NATIONAL MALL UNDERGROUND USACE TECHNICAL REVIEW

Prepared for: National Mall Coalition

Prepared by: U.S. Army Corps of Engineers, Baltimore
District

FINAL SEPTEMBER 2018

Figure 3: Section of Garage/Flood Storage Structure

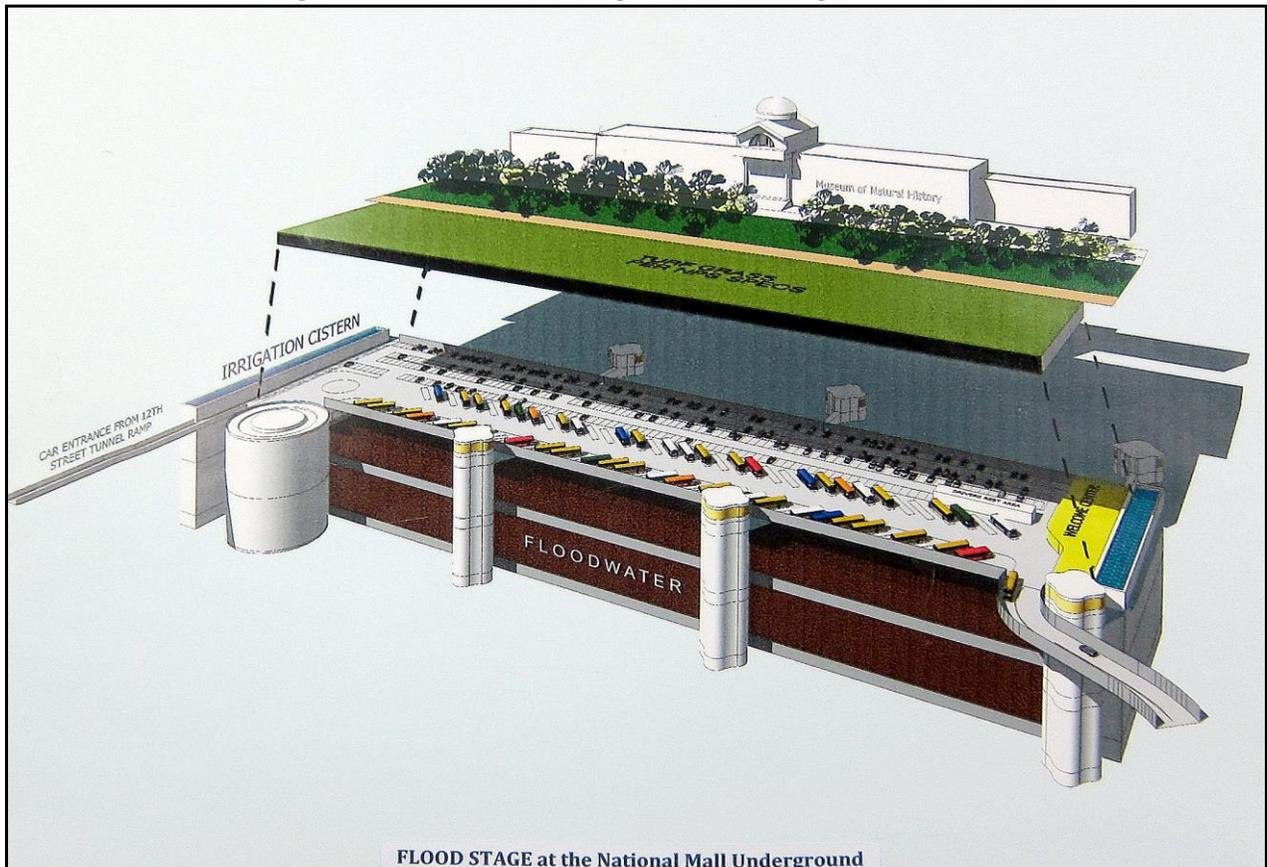
⁵ Alternative reviewed for this technical review only allows for flooding in the lowest level of the parking garage.
